UNITED STATES PATENT AND TRADEMARK OFFICE

APPLICATION NO.	FILING DATE	FIRST NAMED INVENTOR	ATTORNEY DOCKET NO.	CONFIRMATION NO.
09/993,054	11/06/2001	Merrit N. Jacobs	CDS-255	9036

Office Action Summary	Application No. 09/993,054	Applicant(s) JACOBS ET AL.	
	Examiner Brian R. Gordon	Art Unit 1743

DETAILED ACTION

FIG. 5

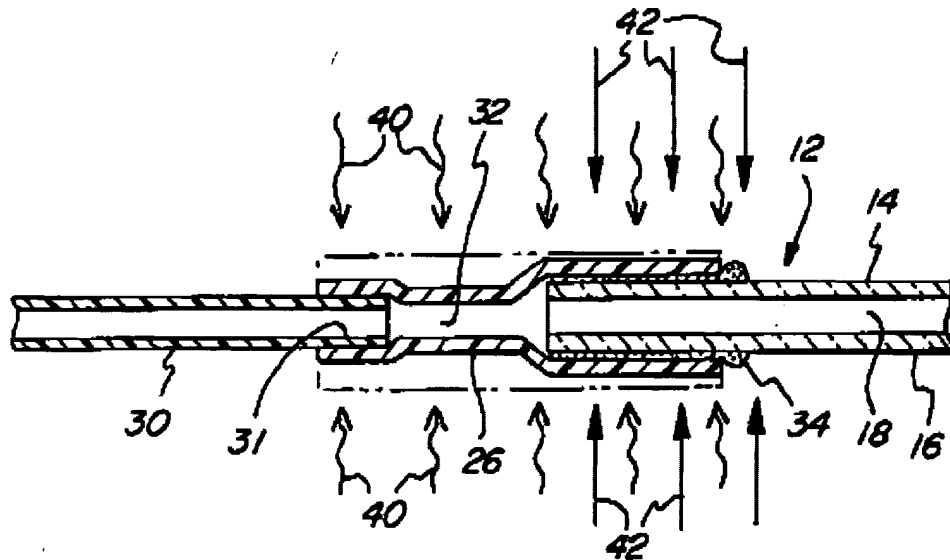
As to claim 20, the examiner directs applicant's attention to Figure 5 (given herein). It is clearly shown in the figure plastic coupling 26, may be manufactured to any desired shape/diameter to couple together various sizes of conduits. The element 26 is very similar to applicants Figure 8. It is clearly seen in the figure that element 26 does comprise transition zones of unequal diameters at each end for the insertion of different sized conduits.

Greenfield discloses a connecting tube device 32 that meets all the limitations of the claim. The tube as seen in Figure 5, comprises 3 cavities formed by a wall, a middle cavity that transitions outward into two adjacent cavities.

Greenfield discloses a connecting tube device 26,32 that meets all the limitations of the claim. The tube as seen in Figure 5, comprises 3 cavities formed by a wall, a middle cavity that transitions outward into two adjacent cavities.

While Figure 5 appears to show tube 26 as meeting the limitation, it would have been obvious to one of ordinary skill in the art at the time of the invention to recognize that the plastic tube 26, 32 may also be formed or heat shrunk to accommodate or allow for the coupling of various sizes of conduits.
